# Access Compliance Report

## Public Rights-of-Way

### (Curb Ramps)

Intersection ID: 31206	Main Street: WESTBURY_GLEN_CT	Cross Street: LARIMER_LN	Location: S
ADA ID: 3D6D500BDBC1	Ramp Type: PerpDiag	Initial Pass/Fail: Fail	Overall Compliance: No
Severity Score: 21.25			
Codes/Mitigation Info/Possible Solution		Field Measurements/Component Compliance

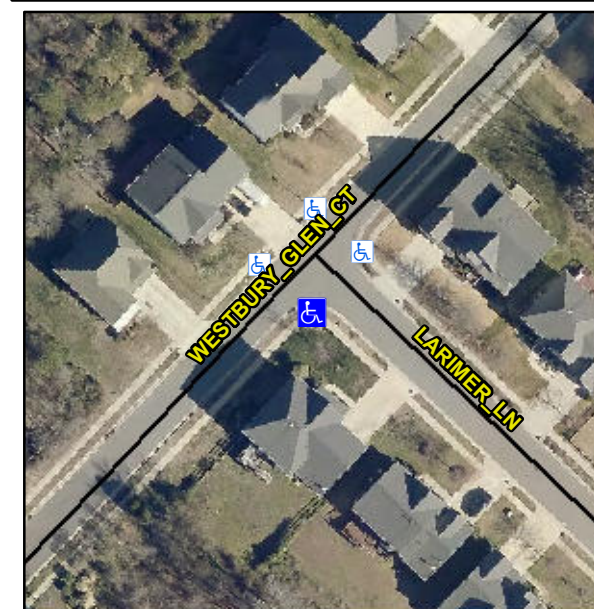
**Not Found, R304.5.1, R304.5.3**

Compliance	Description	Data	Compliance	Description	Data
N/A	Ramp Length (in)	51.0	Yes	Ramp Slope (%)	5.1
No	Ramp Width (in)	37.0	No	Ramp XSlope (%)	6.0
N/A	Flare Type LT	N/A	N/A	Flare Type RT	N/A
N/A	Flare Slope LT (%)	N/A	N/A	Flare Slope RT (%)	N/A
N/A	Flare Traversable LT?	N/A	N/A	Flare Traversable RT?	N/A
N/A	Landing Length (in)	N/A	N/A	DWS Provided?	N/A
N/A	Landing Width (in)	N/A	N/A	DWS Contrast?	N/A
N/A	Landing Slope (%)	N/A	N/A	DWS Length (in)	N/A
N/A	Landing X Slope (%)	N/A	N/A	DWS Full Width?	N/A
N/A	Landing Curb? (Y/N)	N/A	N/A	DWS Offset (in)	N/A
N/A	Shared Landing?	N/A			
N/A	Gutter Ponding?	N/A	N/A	Gutter Slope (%)	N/A
N/A	Gutter Lip Ht (in)	N/A	N/A	Gutter X Slope (%)	N/A
N/A	Painted X Walk1?	No	N/A	Painted X Walk2?	No
	X Walk 1 Direction	To NE		X Walk 2 Direction	To NW
N/A	X Walk 1 Width (in)	N/A	N/A	X Walk 2 Width (in)	N/A
	X Walk 1 Slope (%)	7.3		X Walk 2 Slope (%)	5.9
	X Walk 1 X Slope (%)	4.3		X Walk 2 X Slope (%)	1.0

**Remove & Replace Curb Ramp With Two New Directional Ramps or Equivalent.**
